CITY OF ALBUQUERQUE

December 27, 2021

**RE: The Wymont
4315 Wyoming Blvd NE
Grading and Drainage Plans
Engineer's Stamp Date: 11/02/21
Hydrology File: G19D004**

Based upon the information provided in your submittal received 11/01/2021, the Grading & Drainage Plan **is not** approved for Work Order and Grading Permit. The following comments need to be addressed for approval of the above referenced project:

NOTE

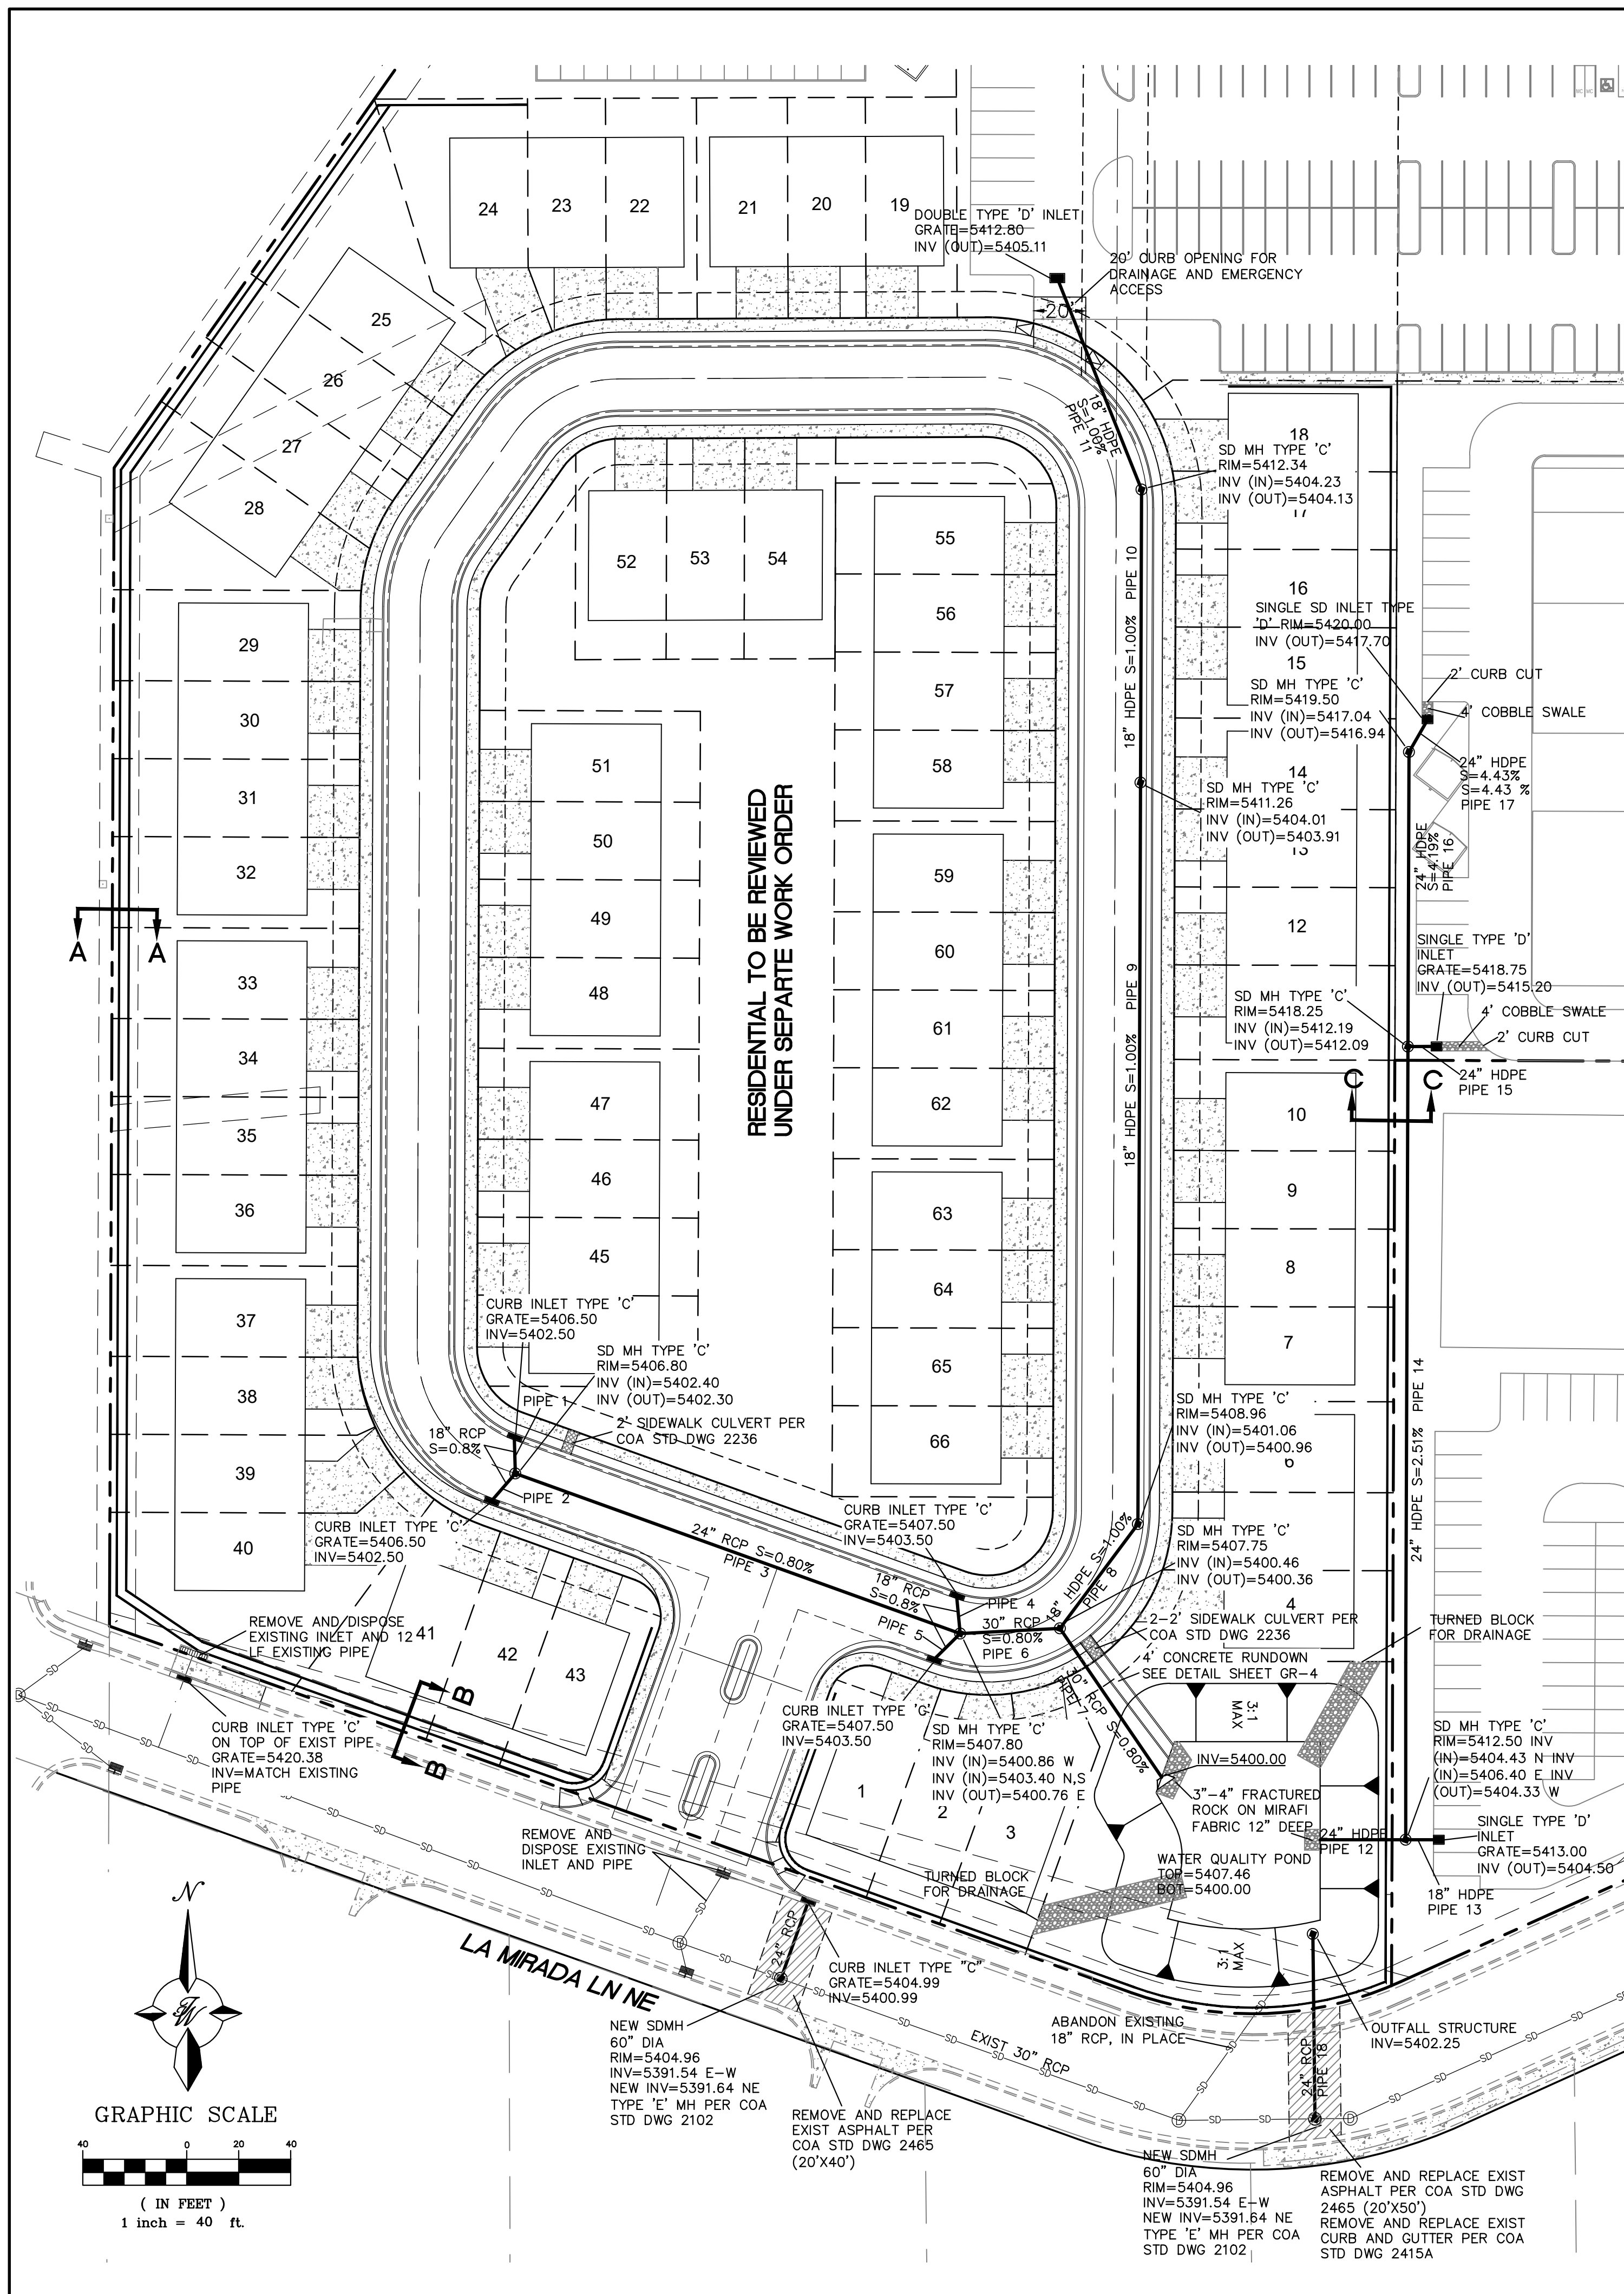
3. GR-1. This is currently very congested and difficult to read. Please, make this sheet just an overall Grading Plan with added pipe sizes, detention pond labeled, proposed contours, and line work with text showing which pipes and grading are to be done under which of the two work orders.

4. GR-1. Please add a note, "Side slopes need to be stabilized with Native Grass Seed (per City Spec 1012) with Aggregate Mulch or equal (Must satisfy the "Final Stabilization criteria" CGP 2.2.14.b.)". This is for the water quality pond.
5. Please make two Grading Plans at 1" = 20'. This will make the grading more readable and less congested.
6. GR-2. As with comment #4, this should be two storm pipe plans at 1" = 20'. Please add the word "Privately maintained" to all on-site storm pipes. This will also include the 24" RCP from the pond outfall structure to the new manhole in La Mirada Lane.
7. GR-3. Please relabel this as Master Drainage Plan.
8. GR-3. The Existing Drainage Area "A" drains to the west and then to the southwest as shown.
